## The Glitch

*Overview:* A solar combisystem is being planned to provide a portion of the space heating and domestic hot water needs of a new “Eco” house being constructed in Vermont. The house will have plenty of south-facing windows to help warm it on sunny winter days.

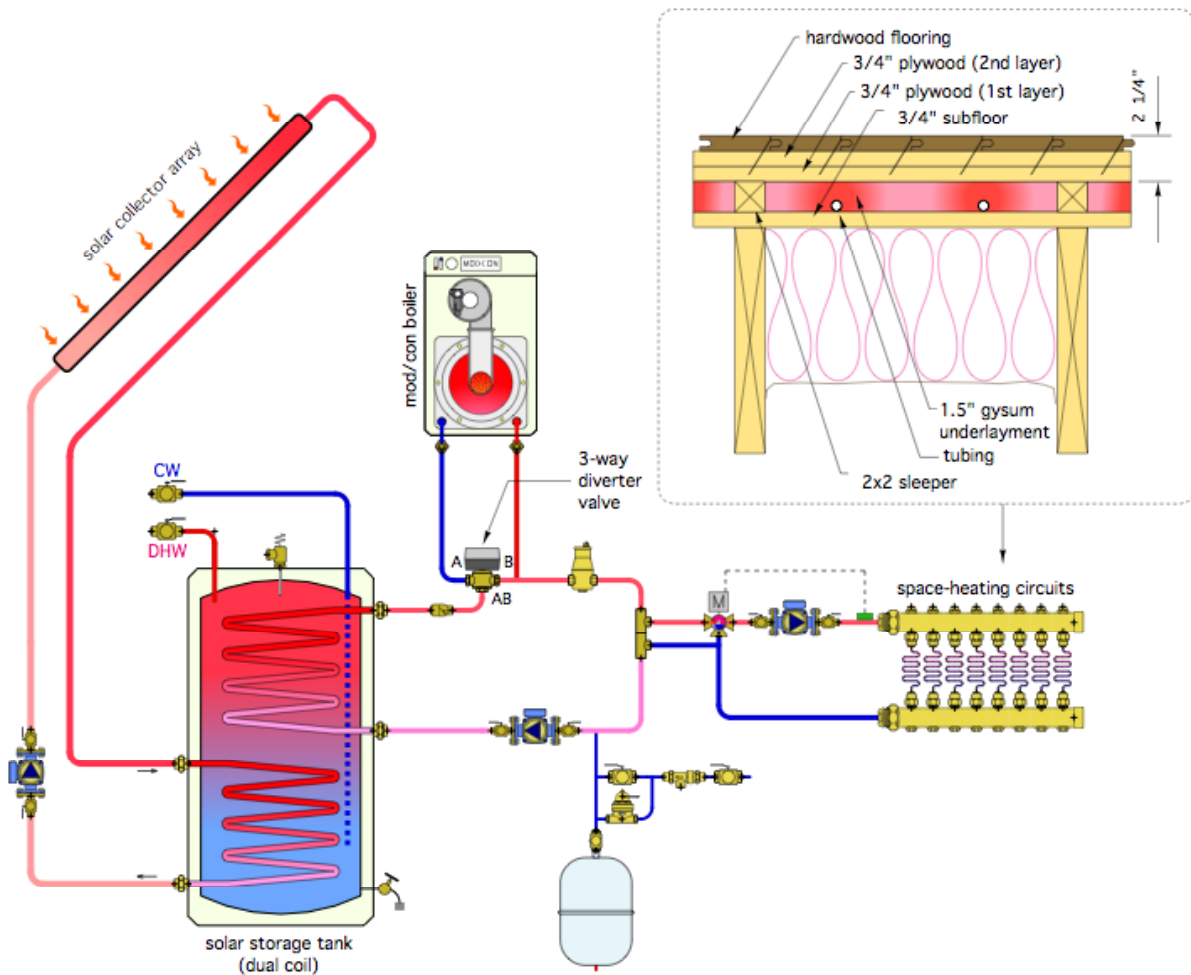
The owner loves the idea of warm floors, but also wants nail-down hardwood flooring. The flooring contractor plans to install that floor as shown in the cross-section below (because he saw this detail in a major home building publication).

*Exercise:* Look over the schematic and the planned floor installation detail. Do you see any problems lying in wait?

The flooring installer doesn't want any issues with keeping that floor flat, so he specifies two overlapping layers of 3/4" plywood for the underlayment. This adds considerable thermal resistance between the water in the tubes and the top surface of the floor. This significantly increases supply water temperature, especially at design load conditions.

Although such a floor would probably operate adequately at design load conditions if supplied with water in the 160 °F range, such temperatures are quite presumptuous for a solar system using flat plate collectors during a cold Vermont winter. The solar energy contribution to space heating in such a system will be very limited.

The original piping schematic is also missing several essential components in the solar collector circuit. It also lacks an anti-scald tempering valve on the domestic hot water piping and purging valves in the space heating system. These components are identified in red on the Fix drawing.
